CITY OF WACO

Addendum No: 2

ADDENDUM NO. 2

Project Name: Bagby Avenue Street Improvements (Kendrick Ave. to South Valley Mills Dr.)

INTERSECTION LAYOUT
IRVING LEE ST
STA 110+00 TO STA 111+50

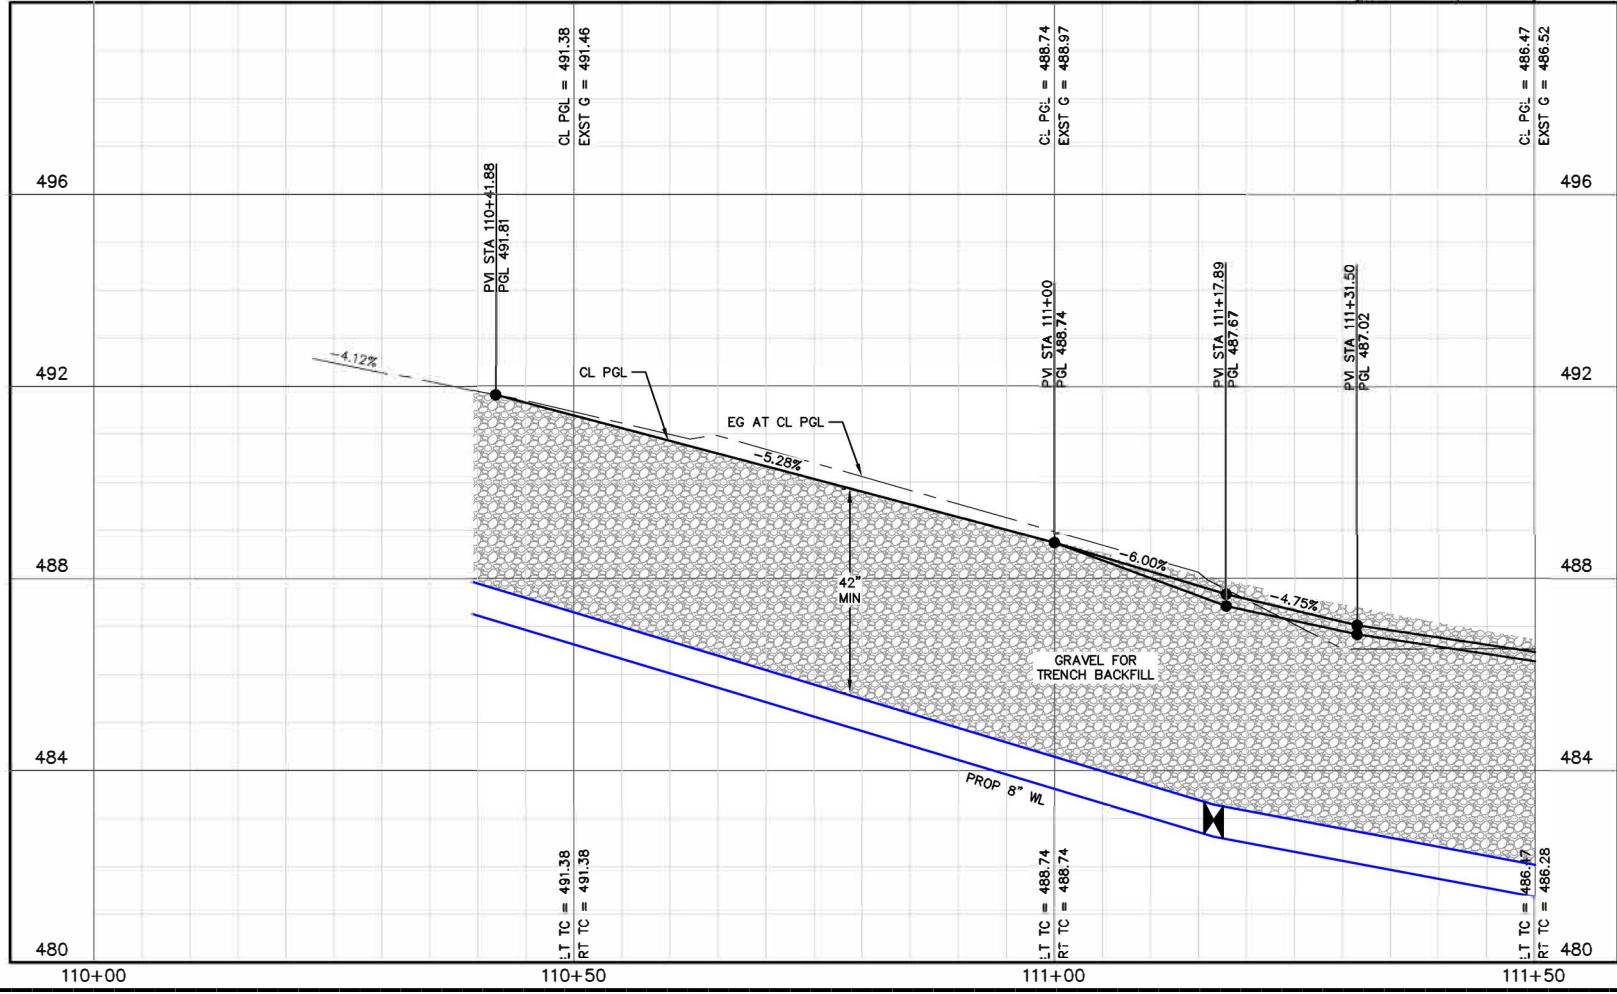
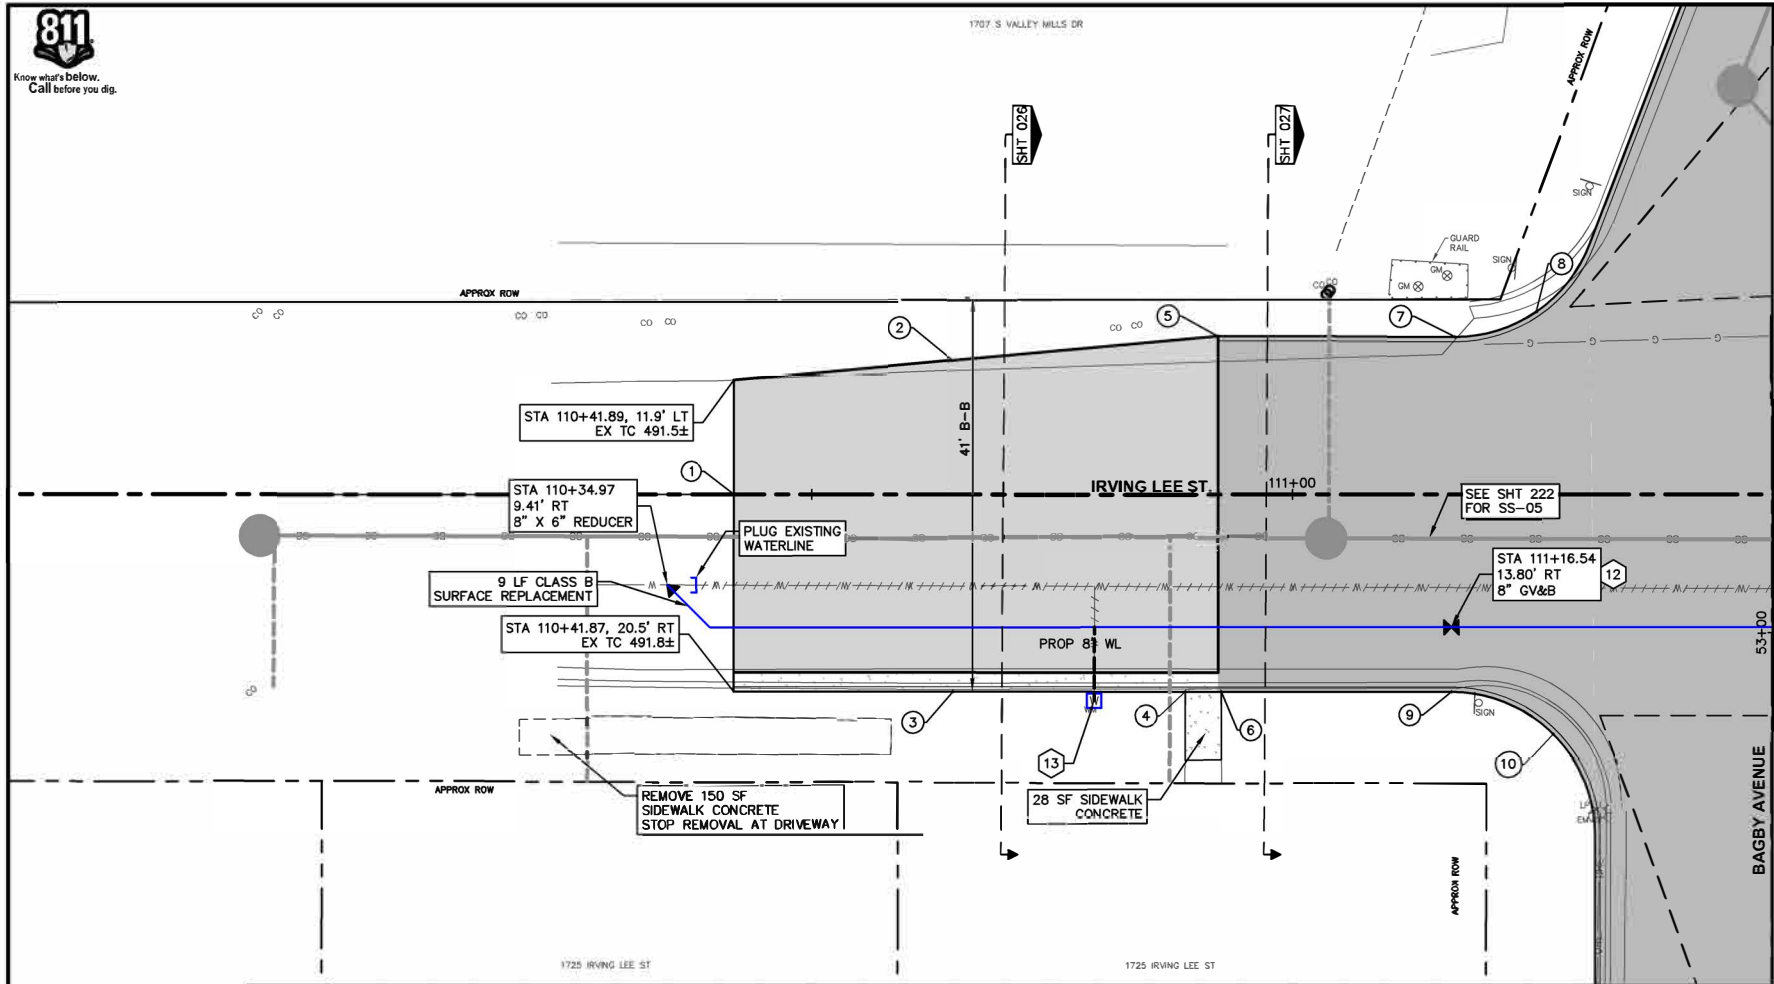
1. Construction drawings have been modified as follows:
 - a) **Sheet 006:** Stairs. A row has been added to show quantities on each of the 100 Sheets.
 - b) **Sheet 009:** ADD QUAN column added for Items 4.14, 4.15, 4.16, & 4.17. The Summary of Retaining Wall Table moved from Sheet 006 to Sheet 009.
 - c) **Sheet 142:** Revised Section Lines for Concrete and HMAC.
